Contract No. EP/SP/66/12

Integrated Waste Management Facilities, Phase 1

Proposal for Proposal for Relocating Marine Water Quality Monitoring Station F1 (Rev B)

Proposal for Relocating Marine Water Quality Monitoring Station F1

Figure 1 – Location of marine water monitoring location of F1 (existing) and F1A (newly proposed) for Cheung Sha Wan fish culture zone

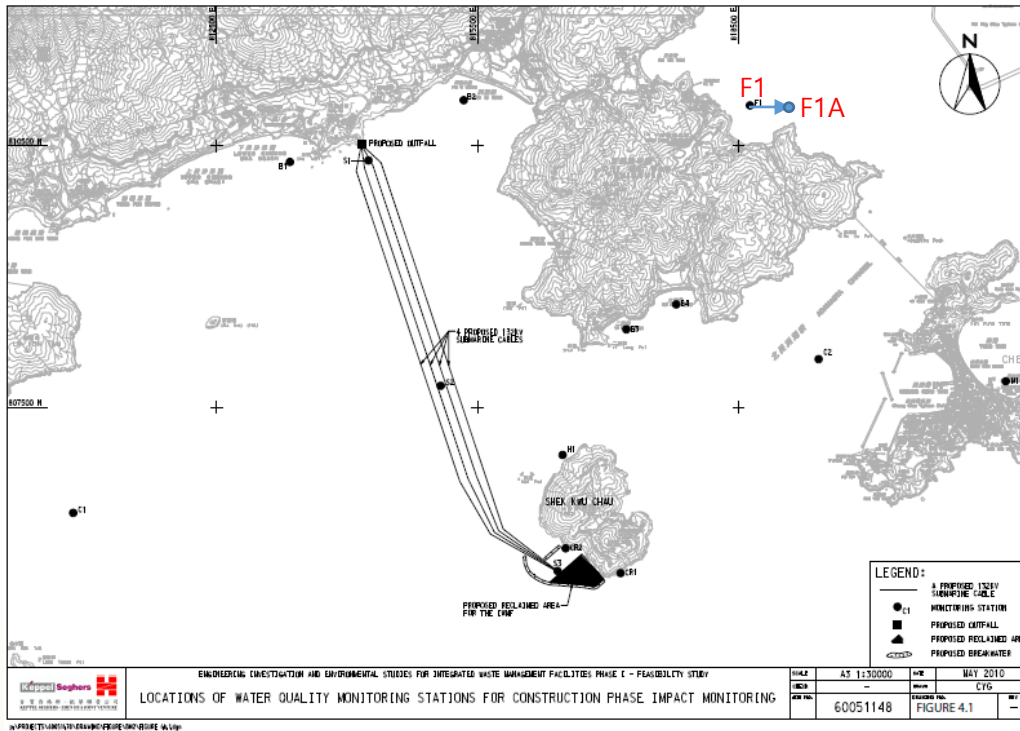
As such and pursuant to Condition 3.1 of the Environmental Permit and 4.3.1 paragraph of EM&A Manual, it is thus proposed to relocate the F1 water monitoring location to a new location to be named as F1A. as shown in Figure 1 for verification by IEC and approval by EPD.

Monitoring Stations	Northing	Easting
F1	810966	818631
F1A	810924	819109

Figure 7 – The Layout of Cheung Sha Wan Fish Culture Zone and Location of CSW2

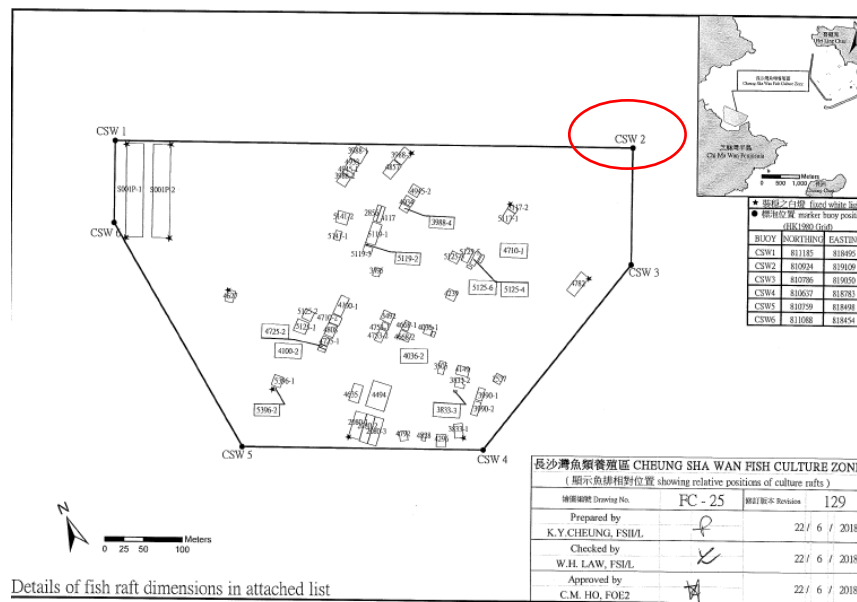
Having considered the above three criteria, we propose to select the location of CSW2 shown in Figure 7. This location is at the boundary of the fish culture zone, having similar sea water influent characteristics from the construction site as for F1, see Figure 8 & 9, and is well known by the mariculturists.
